Lake Hayward Second Beach Park Hazard Identification and Risk Assessment

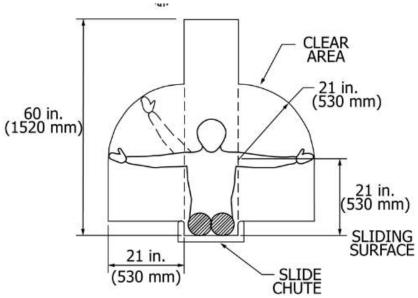
Hazard Identification	Applicable Standard Number	Applicable Standard Text	Injury Risk	Steps to Mitigate
Top of slide fails protrusion test for child's eye socket.	ASTM 1487 – Section 6.3	Protrusions—There shall be no protrusions on public play equipment. Three projection test gauges (shown in Fig. A1.10) and a projection gauge (shown in Fig. A1.11) are required to determine whether projections are protrusions. Their use is described in this section.	Child could be impaled.	Find a way to increase diameter or remove the play feature.

Hazard Identification	Applicable Standard Number	Applicable Standard Text	Injury Risk	Steps to Mitigate
Area where slide meets structure has an entanglement hazard which could catch on a child's clothing.	ASTM 1487 – Section 6.4.1.2	Slides shall be constructed in such a manner as to provide a continuous sliding surface (roller slides exempted) and shall minimize the likelihood of entanglements.	Child could be strangled.	Fill the gap to eliminate entanglement hazard.

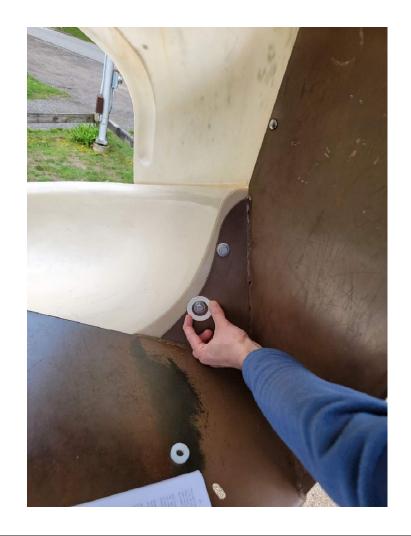
Hazard Identification	Applicable Standard Number	Applicable Standard Text	Injury Risk	Steps to Mitigate
Slide clearance zone is only 10" and is required to be 21"	ASTM 1487 – Section 8.5.6	See above image	Child could be injured while going down slide.	Move the slide.
